#### **ADDENDUM NO. 004**

Brighton Wastewater Treatment System Upgrades

June 2, 2025

A505

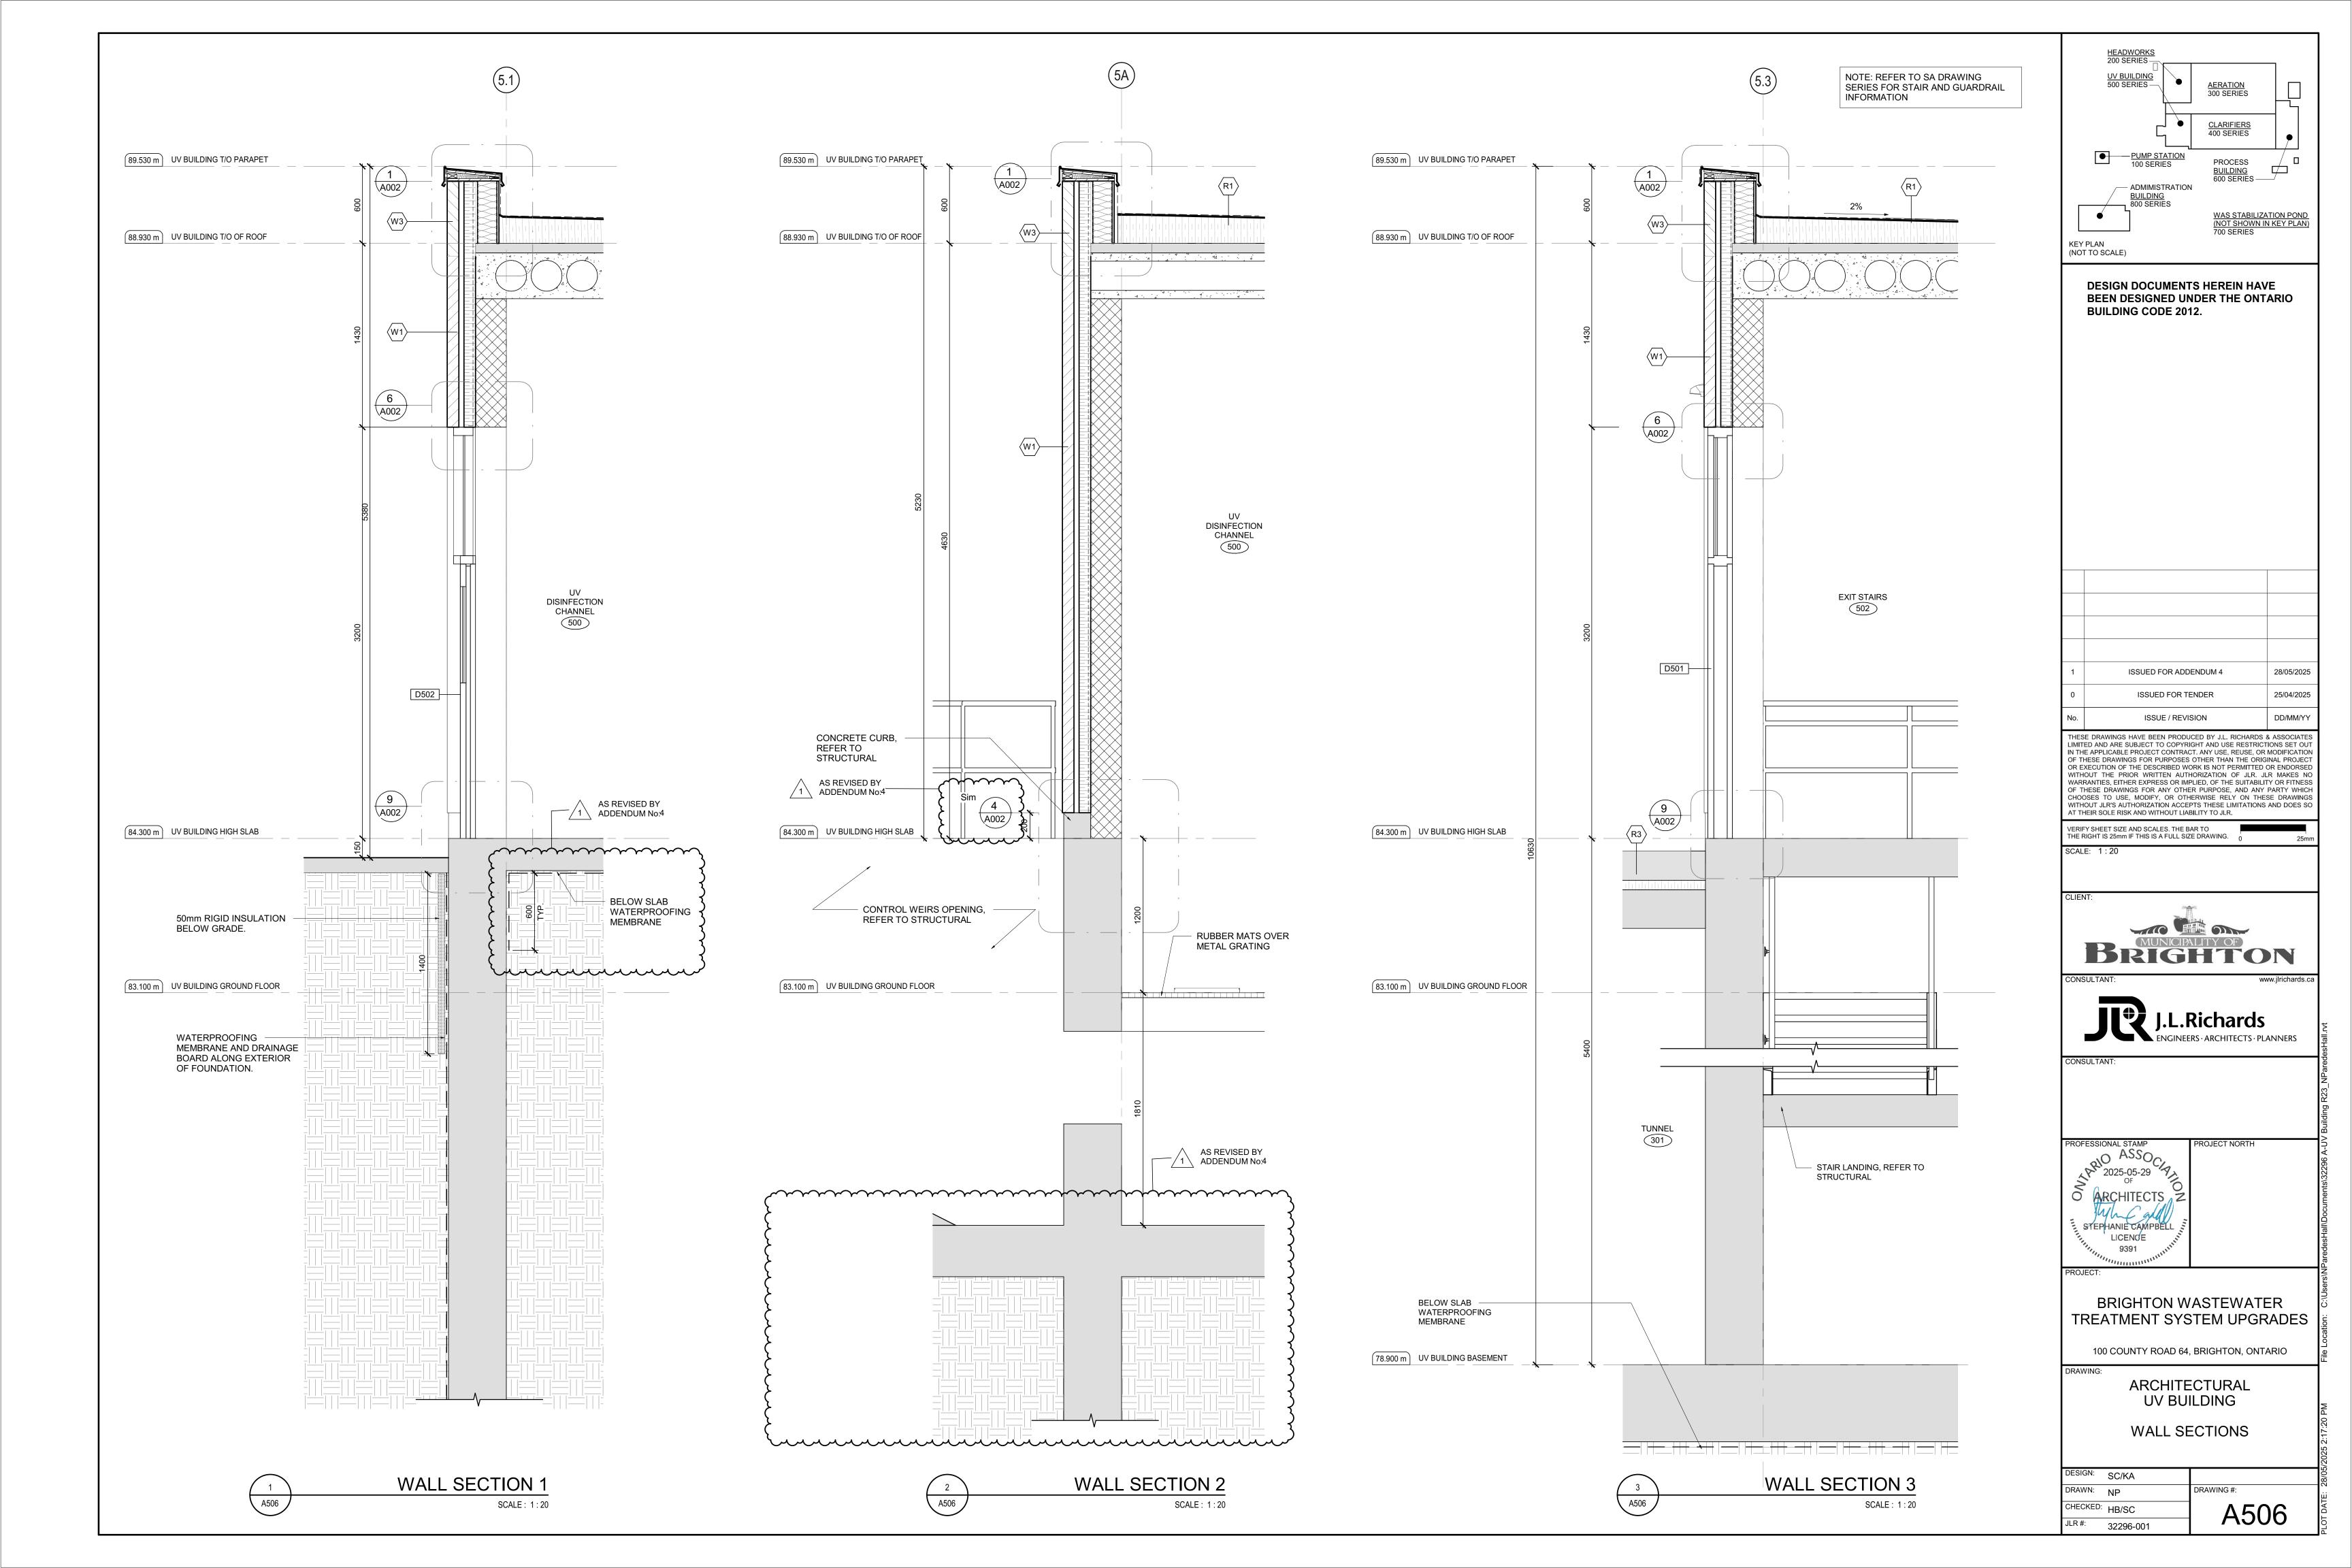
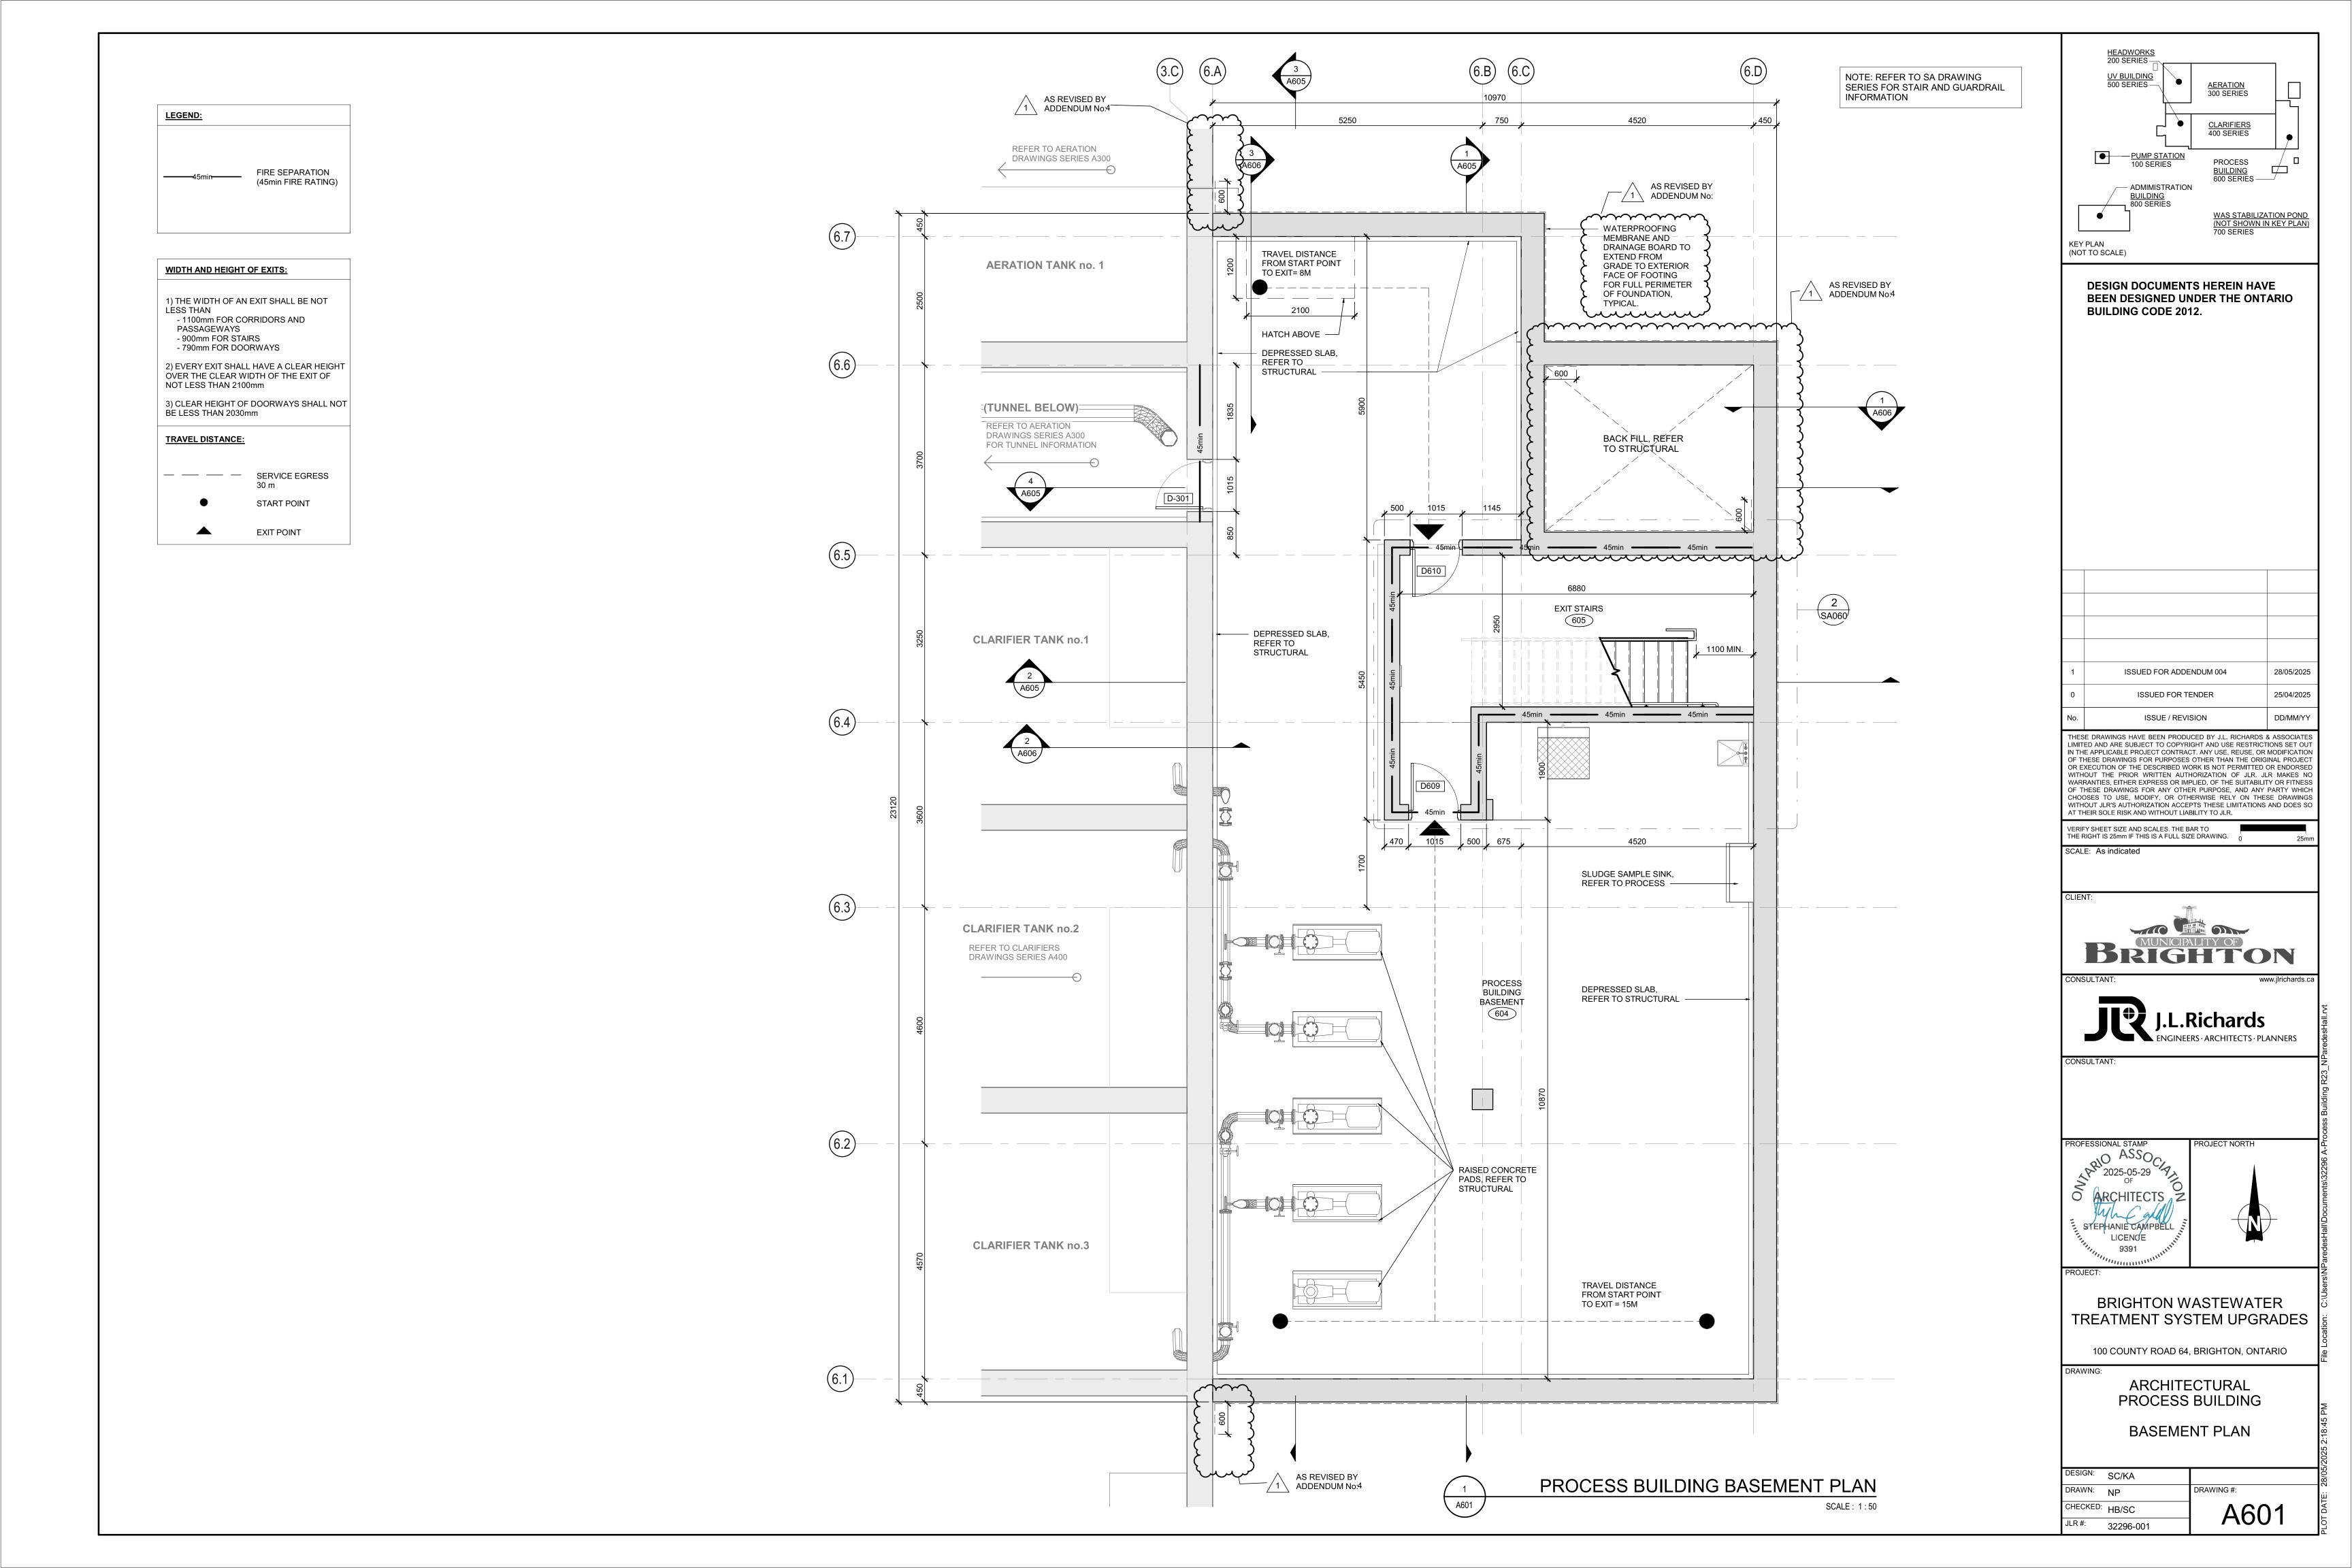
- 12.1 Detail #1
  - .1 **Revise** below grade waterproofing extension as bubbled
  - .2 Add detail 4/A002 callouts and 1/A002.
- 12.2 Detail #2 and #3
  - .1 Add detail 4/A002 callouts and 1/A002.

- 13.1 Detail #1
  - .1 **Revise** below grade waterproofing extension as bubbled.
- 13.2 Detail #2
  - .1 **Remove** below grade waterproofing extension as bubbled.
  - .2 Revise detail 2/A002 callout to read detail 4/A002.
